# UNITED STATES PATENT AND TRADEMARK OFFICE

APPLICATION NO.	FILING DATE	FIRST NAMED INVENTOR	ATTORNEY DOCKET NO.	CONFIRMATION NO.
10/772,736	02/05/2004	Juan-Jann Jou	24061.80 (TSMC2003-0343)	5636
42717	7590	09/20/2006	EXAMINER	
HAYNES AND BOONE, LLP 901 MAIN STREET, SUITE 3100 DALLAS, TX 75202			NGUYEN, THANH T	
			ART UNIT	PAPER NUMBER
			2813

<b>Office Action Summary</b>	<b>Application No.</b>		<b>Applicant(s)</b>	
	10/772,736		JOU ET AL.	
	<b>Examiner</b>		<b>Art Unit</b>	
	Thanh T. Nguyen		2813

## **DETAILED ACTION**

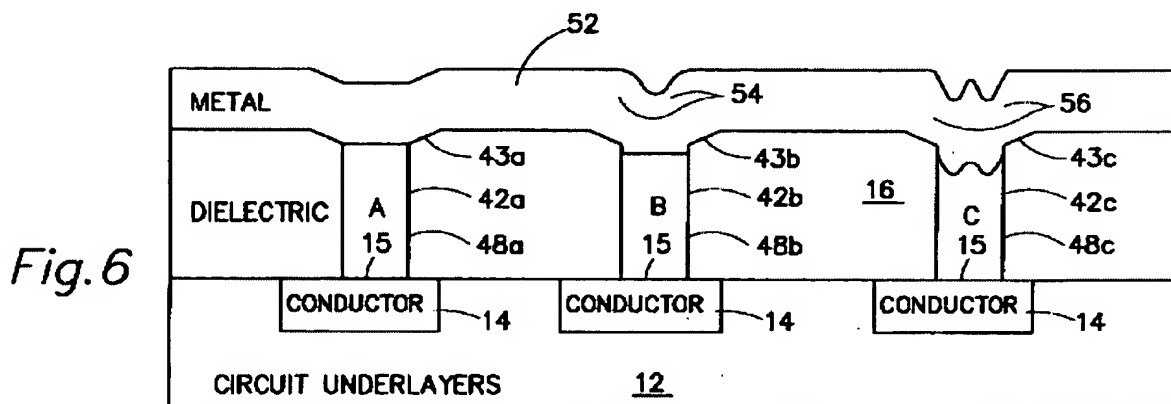
Claims 27, 33, 36, 40-41, 47, 49 are rejected under 35 U.S.C. 102(b) as being anticipated by Straight et al. (U.S. Patent No. 5,567,650).

Referring to figures 3-6, Straight et al. teach an interconnect structure, comprising:

a first conductive layer (48c) located in a substrate (12/14, and the bottom part of layer 16);

a dielectric layer (the top part of layer 16) overlying the first conductive layer (48c) and having an opening (40c) extending to the first conductive layer (48c); and

a second conductive layer (52) located in the opening (40c) and contacting a portion of the first conductive layer (48c), wherein an interface between the first and second conductive layers substantially conforms to a substantially curvilinear profile (see figure 6 for detail).

Regarding to claims 33, 47, wherein the interface profile is substantially W-shaped (see figure 6).

Regarding to claims 36, 49, wherein the interface profile is substantially concave relative to the substrate (see figure 6).

a plurality of second conductive layers (52) located in ones of the plurality of openings (40c) and each contacting a portion of one of the plurality of first conductive layers (48c), wherein each interface between corresponding ones of the first and second conductive layers substantially conforms to a substantially curvilinear profile (see figure 6).

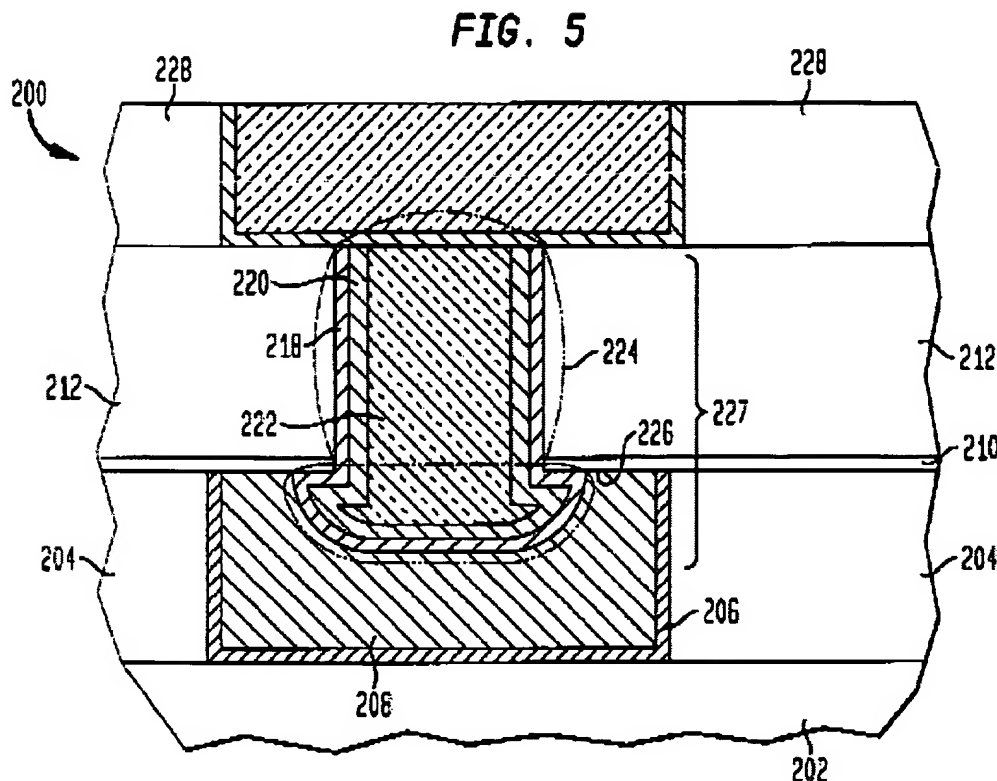
Claims 27, 31-32, 36, 39-41, 45, 46, 49 are rejected under 35 U.S.C. 102(e) as being anticipated by Barth et al. (U.S. Patent No. 6,613,664).

Referring to figures 4-5, 8, Barth et al. teach an interconnect structure, comprising:

a first conductive layer (208) located in a substrate (202/204);

a dielectric layer (210/212) overlying the first conductive layer (208) and having an opening (213) extending to the first conductive layer (208); and

a second conductive layer (218/220/222) located in the opening (213) and contacting a portion of the first conductive layer (208), wherein an interface between the first and second

conductive layers substantially conforms to a substantially curvilinear profile (see figure 5 for detail).

Regarding to claim 31, 45, diffusion barrier layer (218) interposing the dielectric layer and the second conductive layer (see figure 5).

Regarding to claim 32, 46, diffusion barrier layer (218) interposing the first and second conductive layer and substantially conforming to the interface profile (see figure 5).

Regarding to claims 36, 49, wherein the interface profile is substantially concave relative to the substrate (see figure 5).
